**ADDENDUM No. 1**

**Lincoln and Adams Elementary Schools 2024 Kitchen Upgrades**

Arch. Project #220117

## ADDENDUM NO. 1

## A1.1

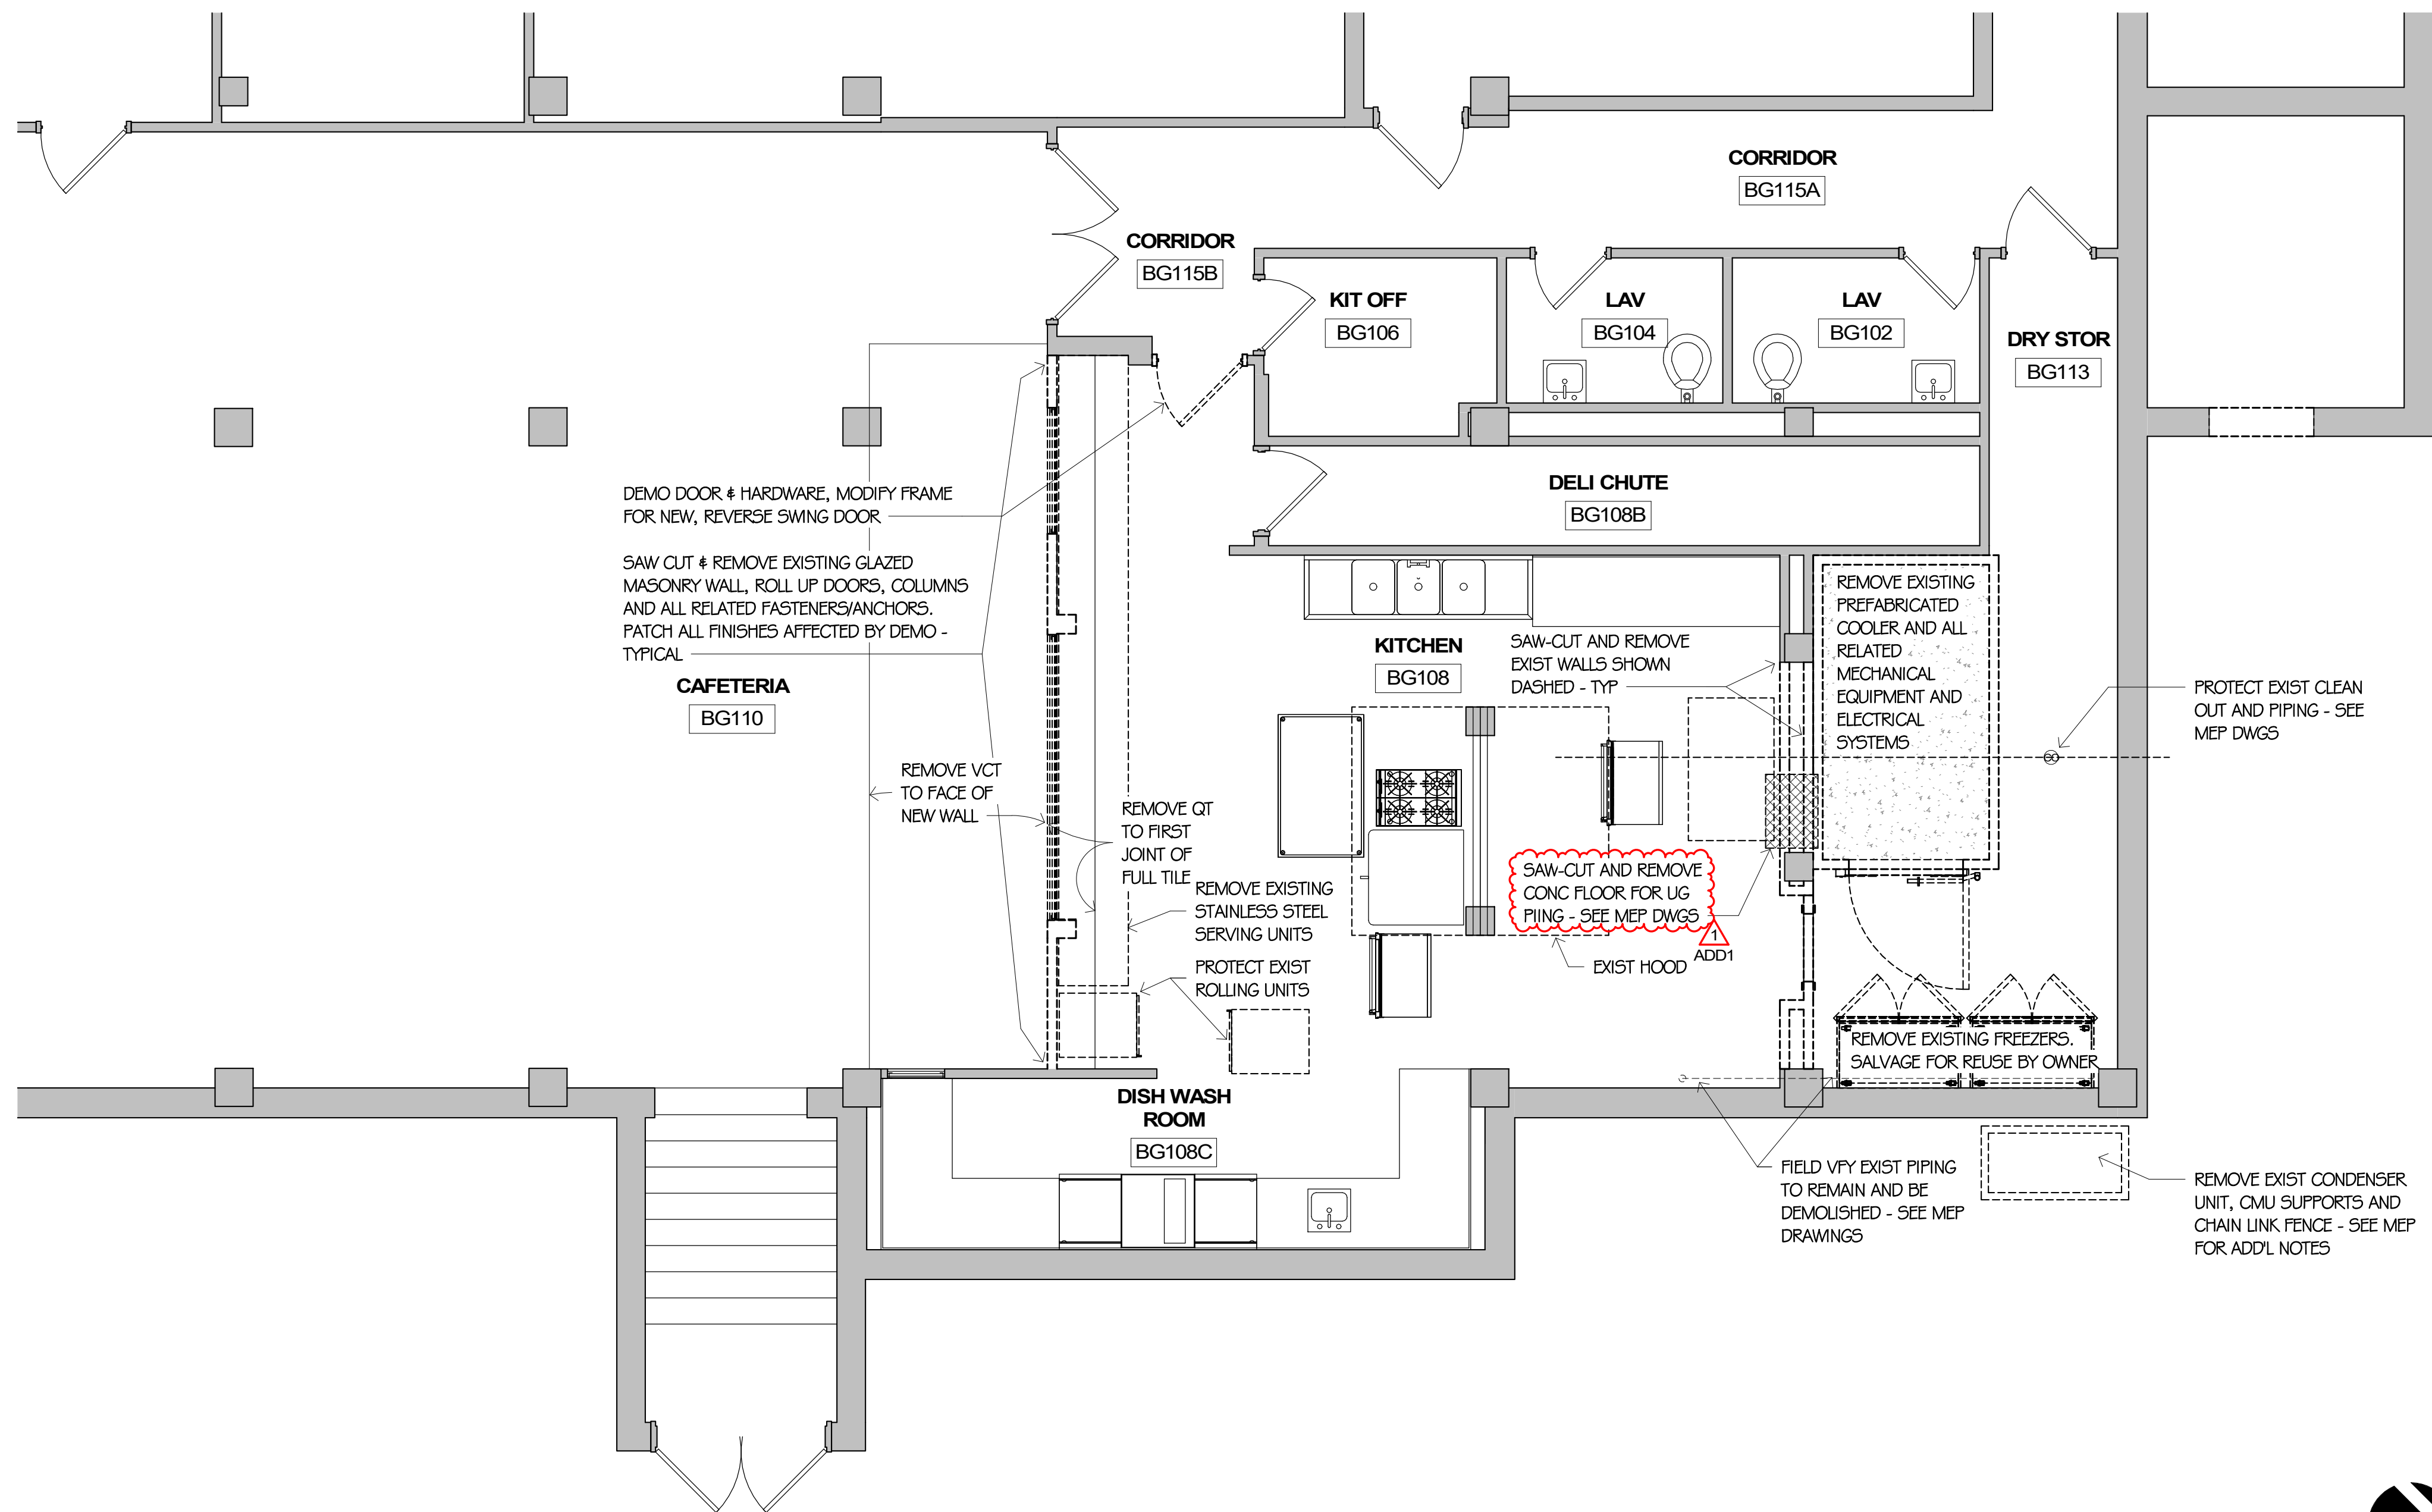
Item 2 Sheet A1.1: Show floor cutting for new UG piping.

## A1.2

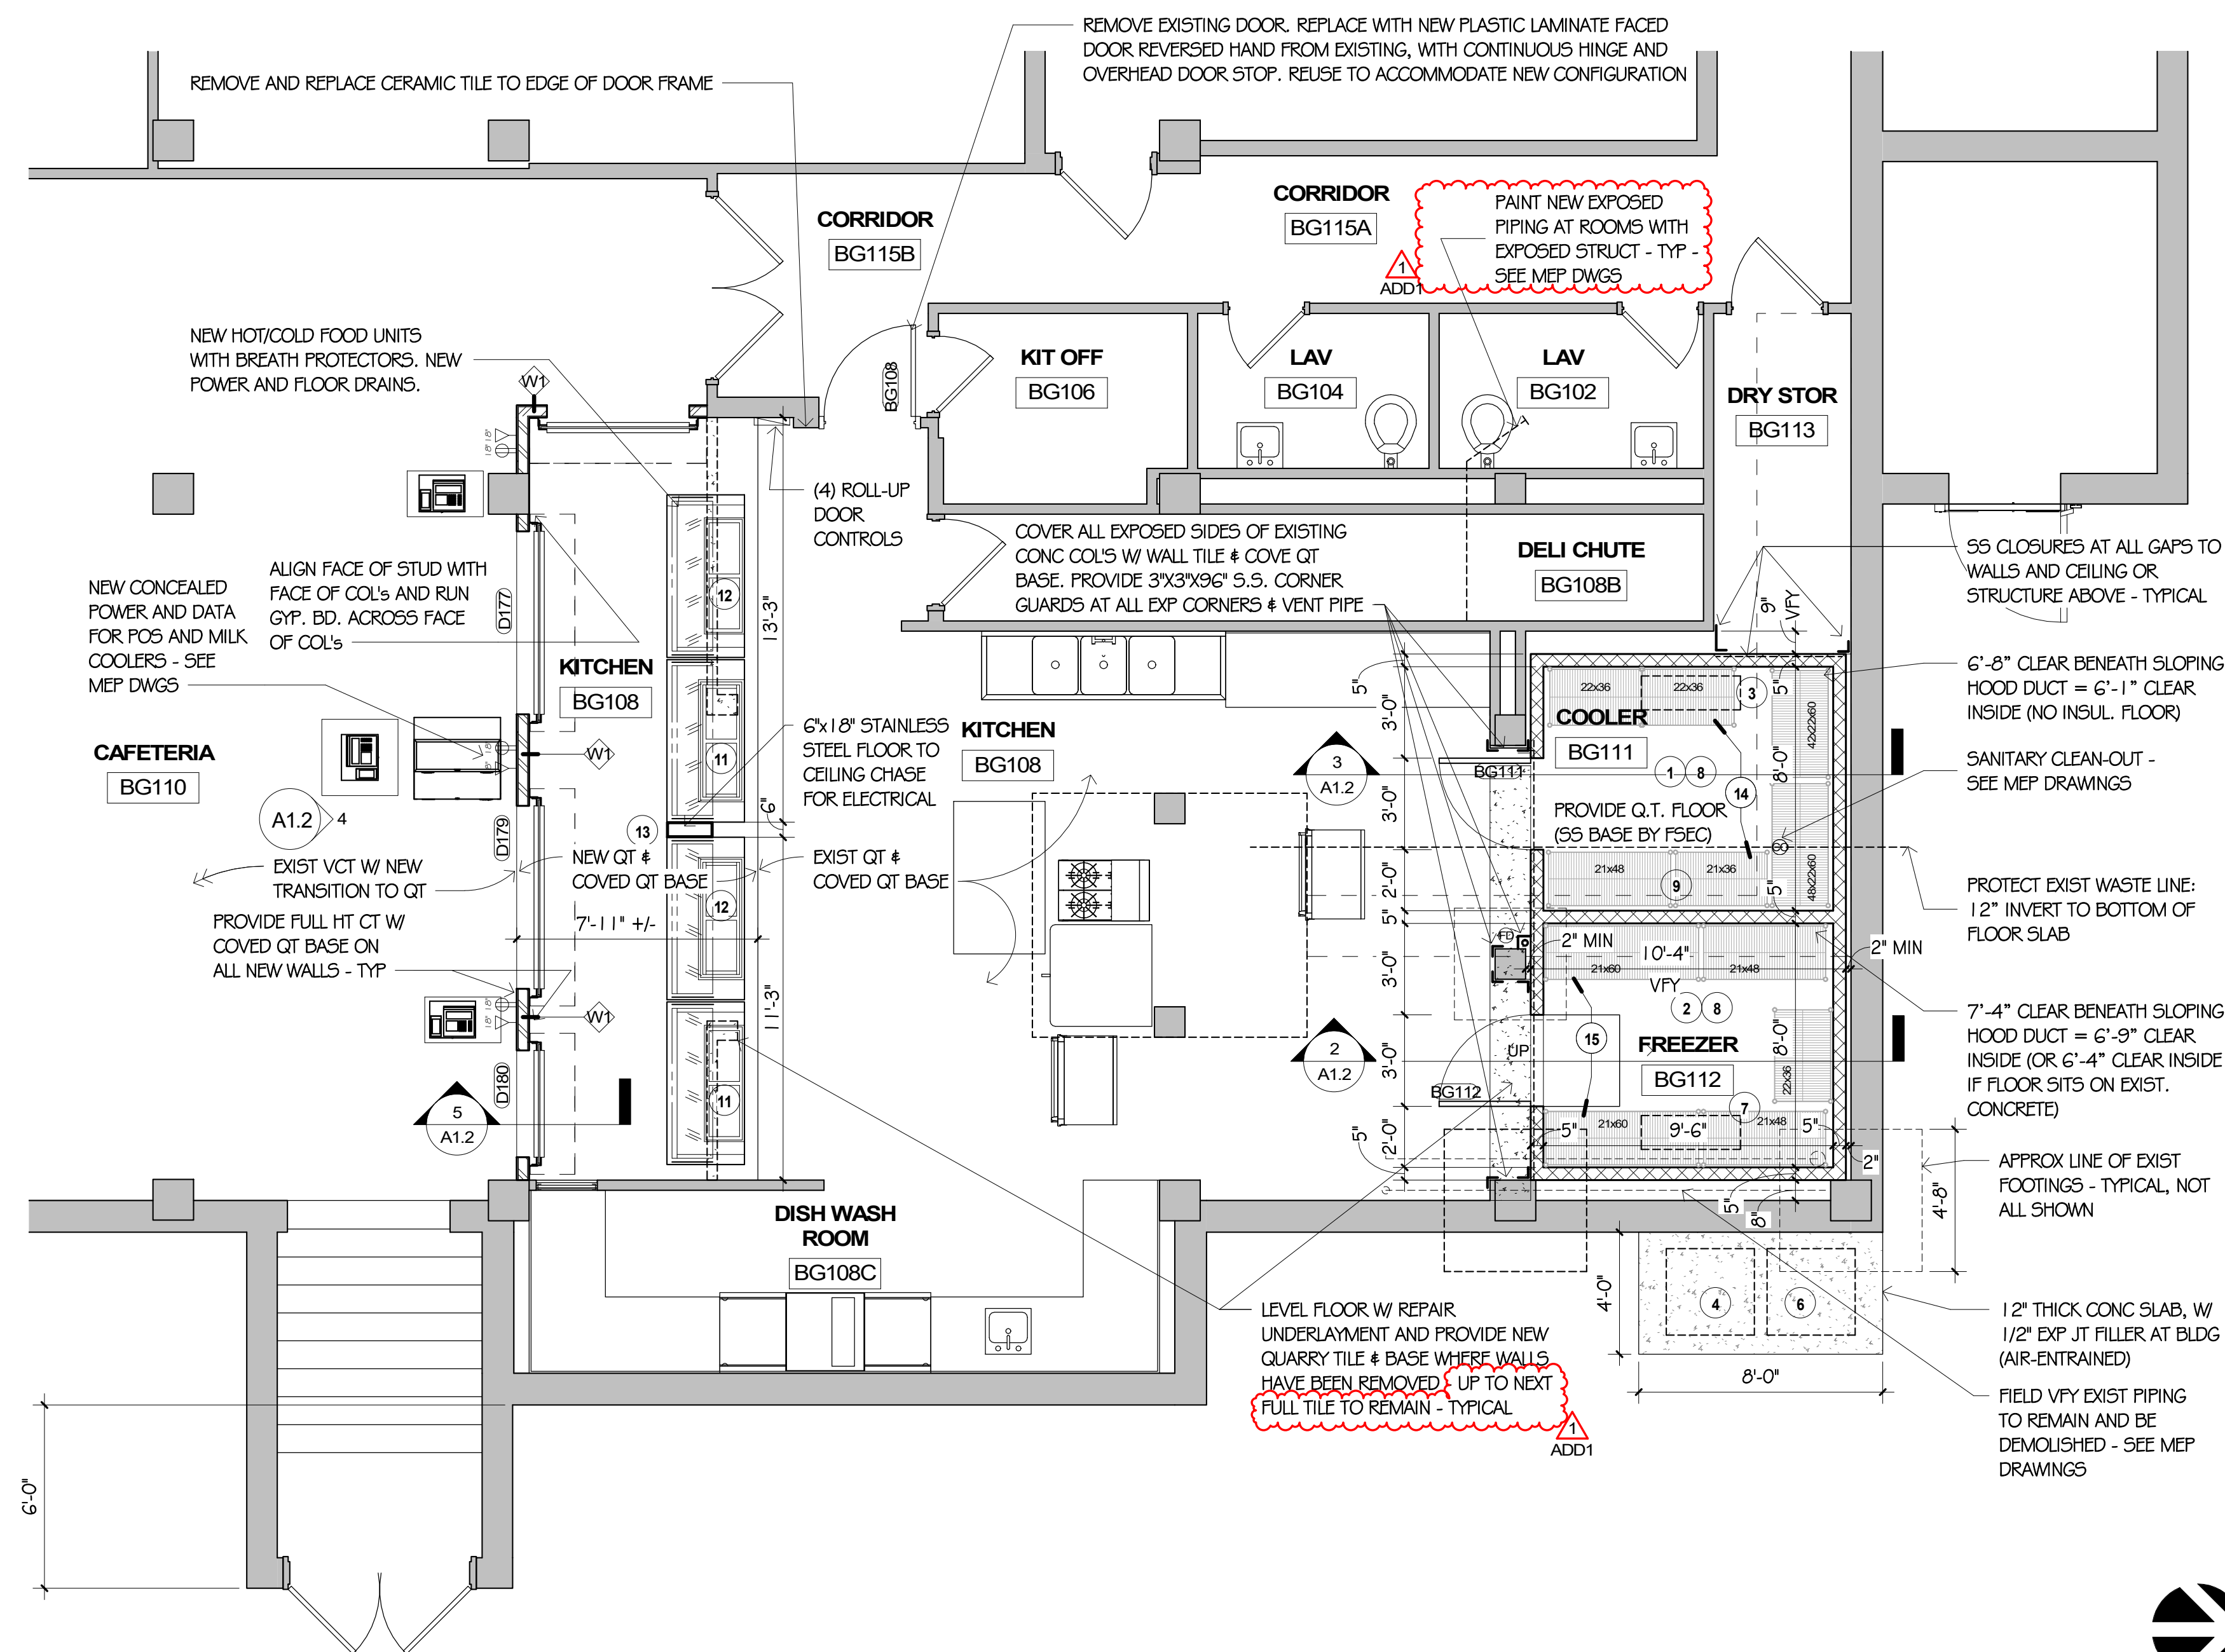
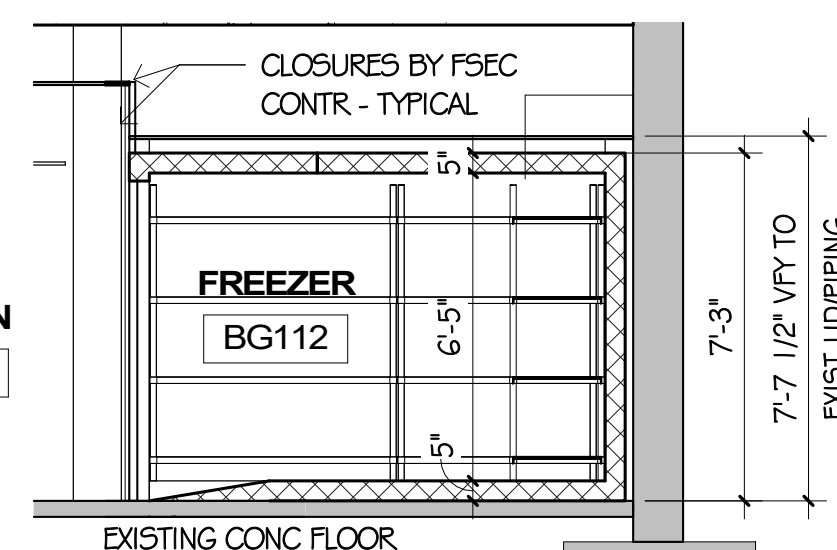
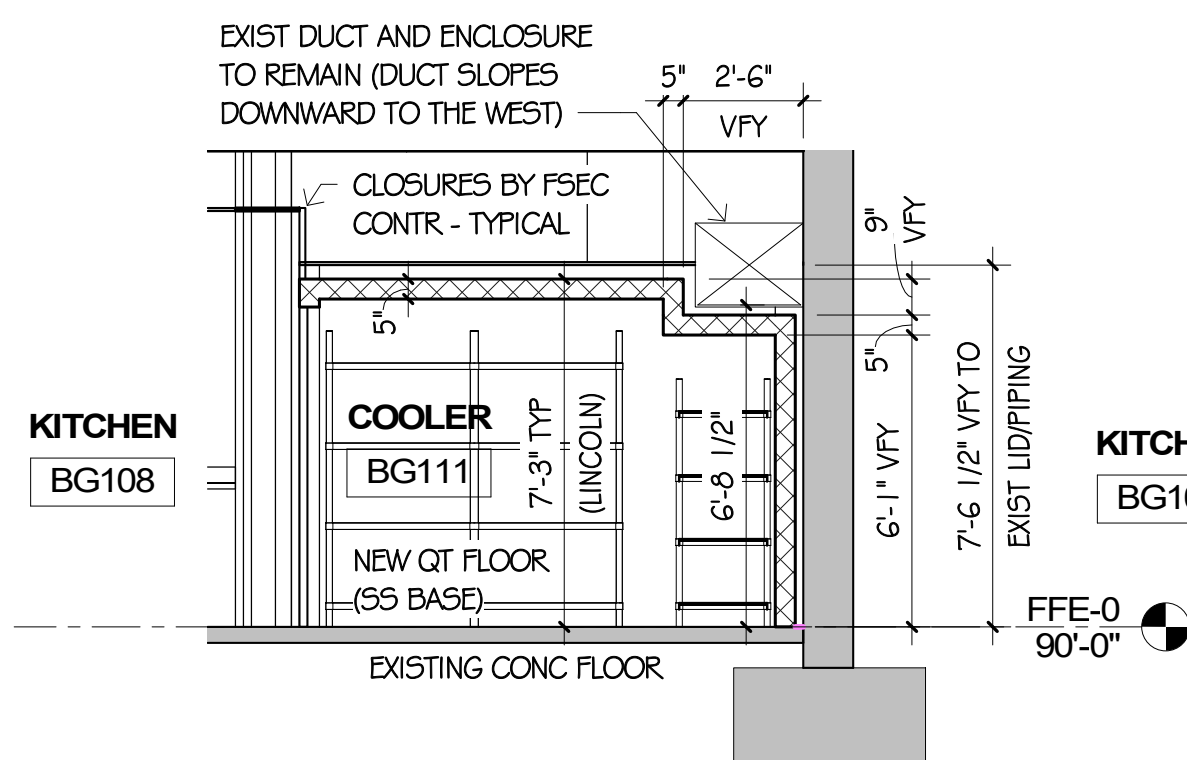
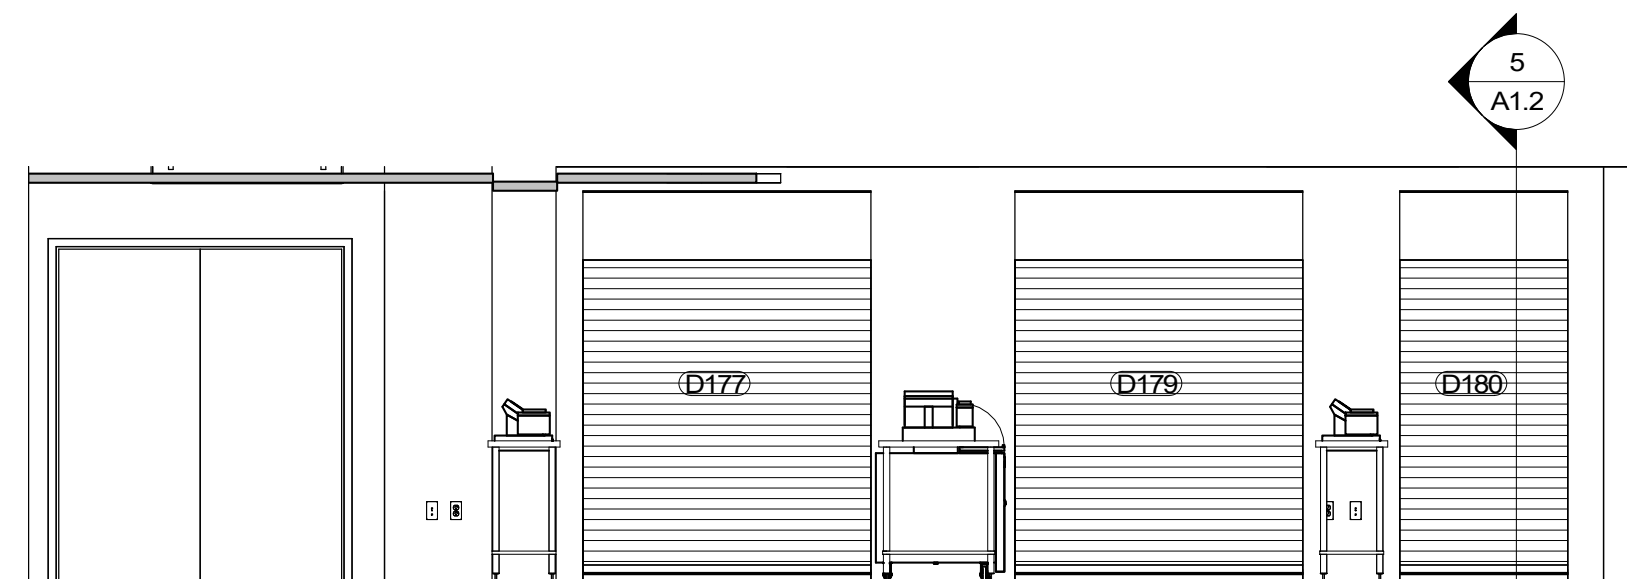
**Item 3 Sheet A1.2:** Paint new piping in rooms with exposed structure above.
